**Amendments to the Drawings:**

## **REMARKS**

Appl. No. 10/510,525  
Response dated November 11, 2005  
Response to Office action of August 11, 2005

Fig 1 (Prior Art)

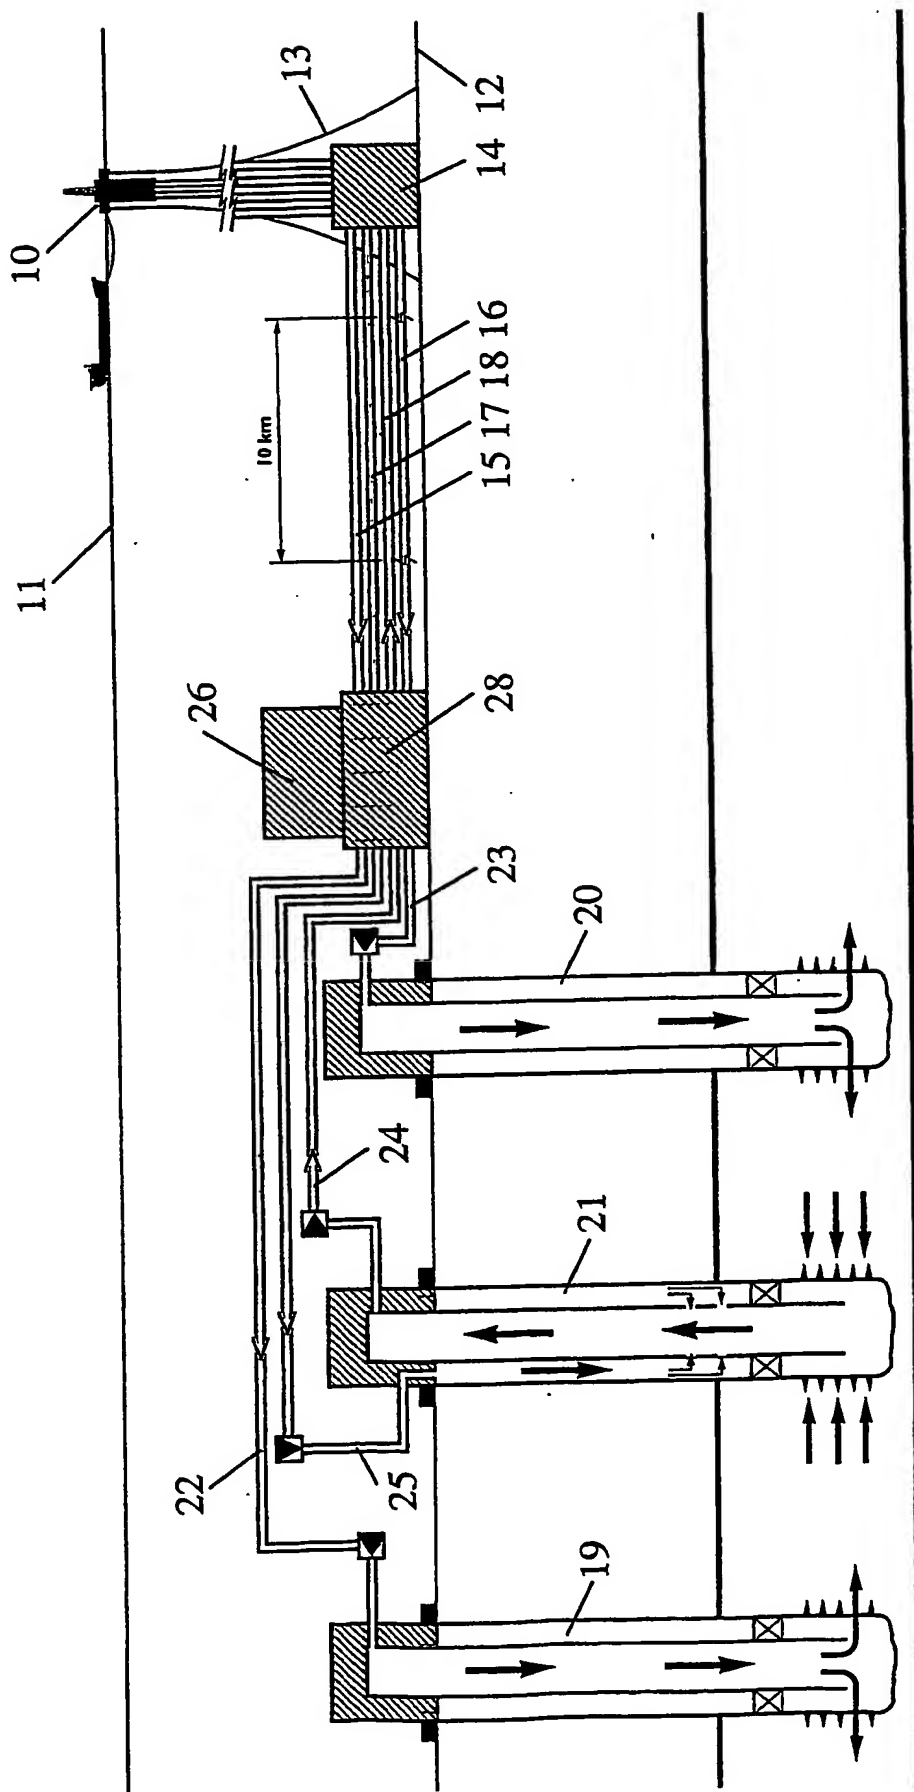
The attached annotated sheets of drawings include changes to Figures 1, 2, and 11. These sheets, which include Figures 1, 2, and 11, show the changes to the original sheets including Figures 1, 2, and 11. In Figures 1, and 2, the text "(Prior Art)" has been added. In Figure 11, reference characters 156, 157, 158, and 159 have been removed.

In amended Figures 1 and 2, the text "(Prior Art)" has been added. In amended Figure 11, the element numerals 156, 157, 158, and 159 have been removed.
